Review of Flood Related Matters Proposed Temporary School Site at Old Kings School Oval, 24 O'Connell Street & 3 Marist Place, Parramatta NSW

for Eco Logical Australia Pty Ltd

Ref: 16108 Report 001 Rev 1 Flood Study.doc

Figure 2.1-1 Subject Site and 1% AEP Flood Affection

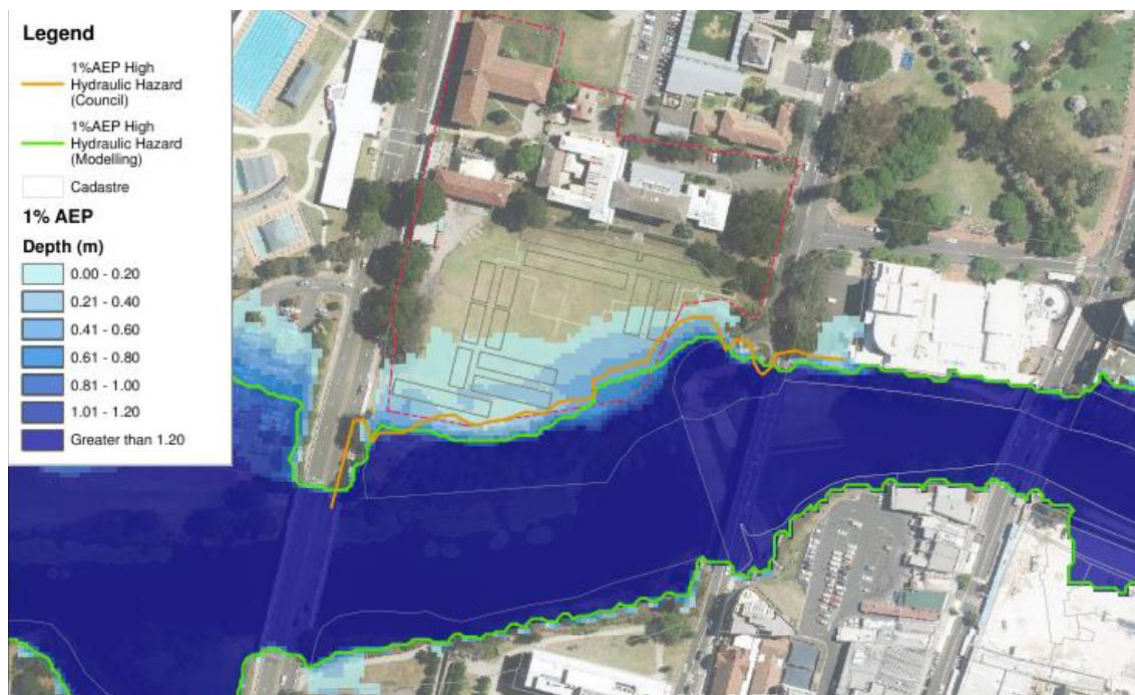
Figure 2.1-1 describes the subject site, and shows the proposed location of the demountable buildings (in grey). The 1% AEP flood extent and depths are also shown as blue shading (via the legend).
